Subject: Duke Energy Corporation
Catawba Nuclear Station, Units 1 and 2
Docket Numbers 50-413 and 50-414

Proposed Technical Specifications and Bases
Amendment
Technical Specification and Bases 3.6.10
Annulus Ventilation System (AVS)
Technical Specification and Bases 3.6.16
Reactor Building
Technical Specification Bases 3.7.10
Control Room Area Ventilation System (CRAVS)
Technical Specification Bases 3.7.12
Auxiliary Building Filtered Ventilation Exhaust
System (ABFVES)
Technical Specification Bases 3.7.13
Fuel Handling Ventilation Exhaust System (FHVES)
Technical Specification and Bases 3.9.3
Containment Penetrations
Technical Specification 5.5.11
Ventilation Filter Testing Program (VFTP)
TAC Numbers MB7014 and MB7015

RESPONSE TO NRC REQUEST FOR ADDITIONAL INFORMATION

2.2 COMPARISON WITH SIMULATION OF BYPASS AIRFLOW PATH

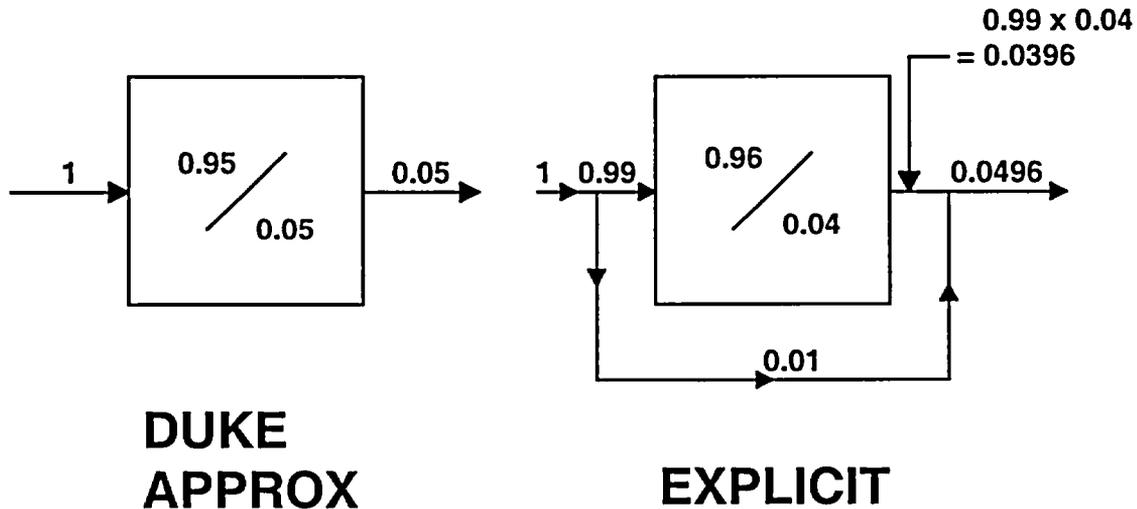
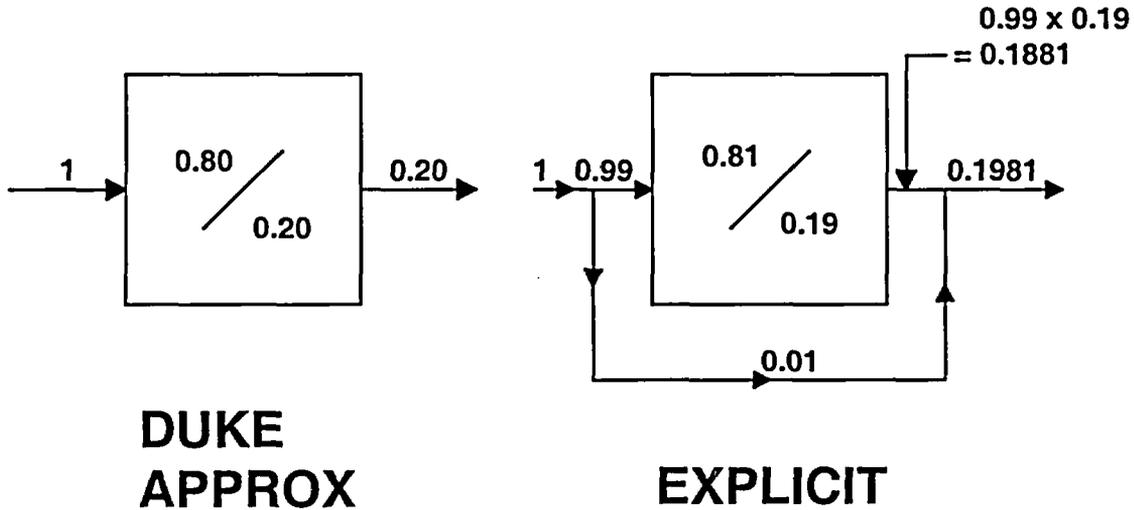
- 2) It is the staff position that charcoal filter testing should be done in accordance with the guidance of RG 1.52, Rev. 2, as has been committed to by the Catawba Plant. As such, a 2 inch charcoal filter should be tested to a laboratory efficiency of 97.5%, thereby permitting licensee to claim 95% efficiency for both organic and elemental iodine in the dose analysis while providing a safety factor of 2, as outlined in GL 99-02. See Regulatory Position 6.a in RG 1.52, Rev. 2, and GL 99-02 for further discussion of the staff's position. Considering this discussion on filter testing and assumed filter efficiency in dose analyses, the explanation of how Catawba has accounted for the 1% system bypass for the in-place testing by adjusting the filter efficiency is not clear to the staff. Provide a clear explanation of how the allowable bypass is accounted for in your dose analysis.

The degree of conservatism in the model employed within Duke may be calculated by taking $1 - \eta_p = 0.04$ for diatomic iodine and $f_f = 0.01$ for diatomic iodine bypass. Set f_f and f_b to 0.99 and 0.01. The resulting values for $1 - \eta_T$ and comparison to $1 - \eta_d$ are presented below:

For diatomic iodine, $1 - \eta_T = 0.0496$ vs. $1 - \eta_d = 0.05$.

The following is a pictorial demonstration of this comparison for diatomic iodine:

For organic iodine compounds, $1 - \eta_T = 0.1981$ vs. $1 - \eta_d = 0.2$. The pictorial demonstration of this comparison for organic iodine compounds follows as:
